[Docket No. FAA-2023-0671; Project Identifier AD-2022-01428-T; Amendment 39-22469; AD 2023-12-11]

Airworthiness Directives; The Boeing Company Airplanes

ACTION: Final rule.

2023–12–11 The Boeing Company:
Amendment 39–22469; Docket No. FAA–2023–0671; Project Identifier AD–2022–01428–T.

Figure 1 to paragraph (g)(2)(i)—*Fundamental Effective Isotropic PSD at Outside Interface of Aircraft Antenna*

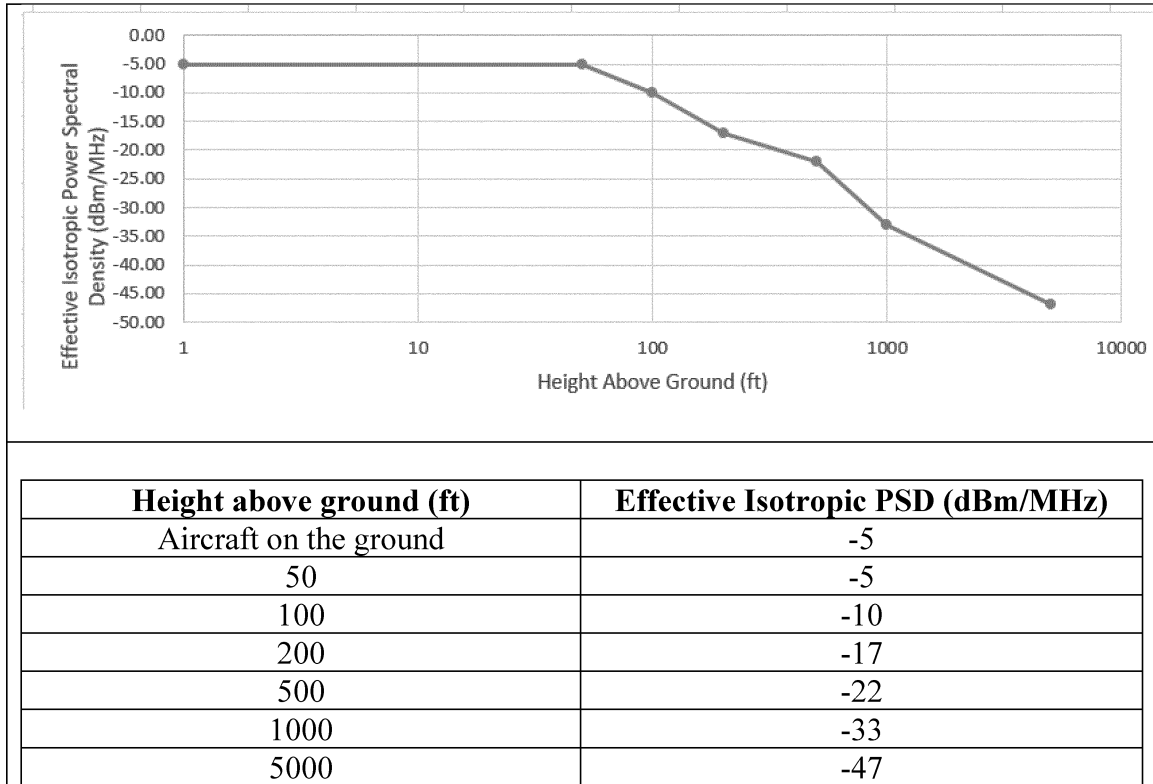
(2) For purposes of this AD, a “radio altimeter tolerant airplane” is one for which the radio altimeter, as installed, demonstrates the tolerances specified in paragraphs (g)(2)(i) and (ii) of this AD, using a method approved by the FAA.

(i) Tolerance to radio altimeter interference, for the fundamental emissions (3.7–3.98 GHz), at or above the power spectral density (PSD) curve threshold specified in figure 1 to paragraph (g)(2)(i) of this AD.

Figure 2 to paragraph (g)(2)(ii)—*Spurious Effective Isotropic PSD at Outside Interface of Aircraft Antenna*

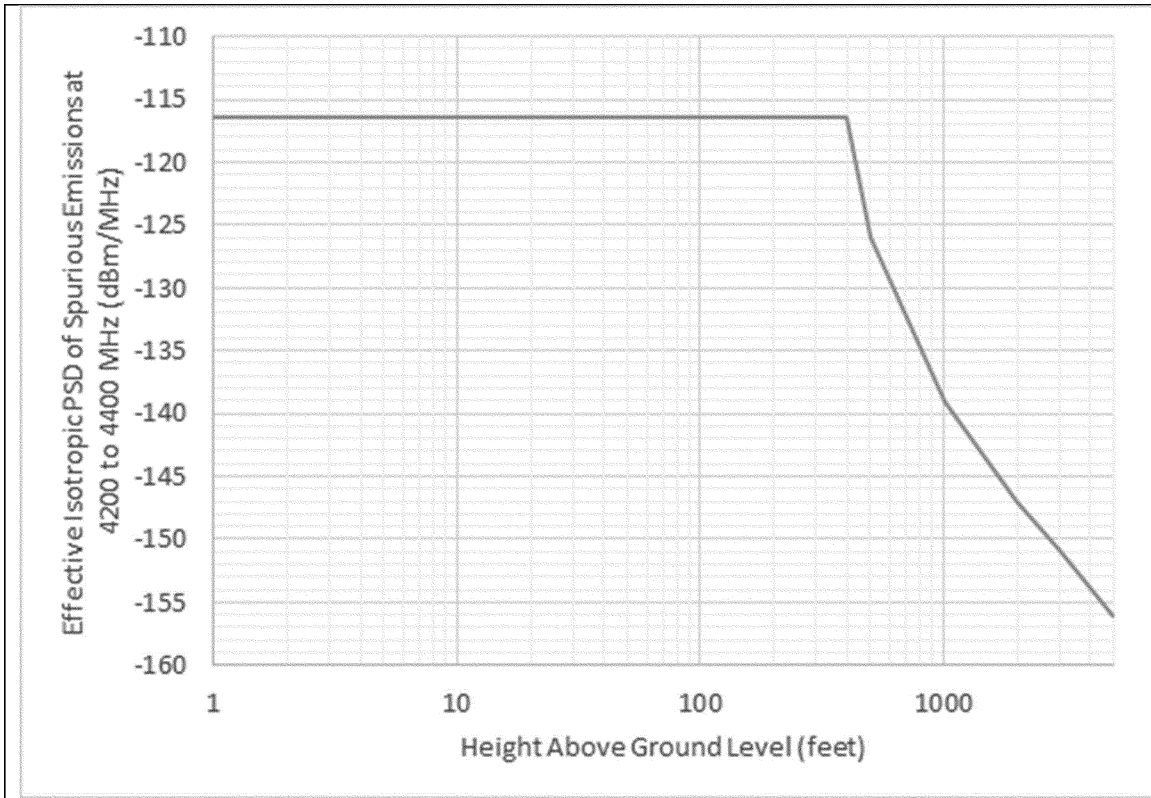
(ii) Tolerance to radio altimeter interference, for the spurious emissions (3.7–

3.98 GHz), at or above the PSD curve

threshold specified in figure 2 to paragraph (g)(2)(ii) of this AD.

<u>Aircraft Altitude (ft AGL)</u>	<u>Effective Isotropic PSD (dBm/MHz)</u>
1	-116.50
400	-116.50
500	-126.00
1000	-139.00
2000	-147.00
3000	-151.00
5000	-156.00
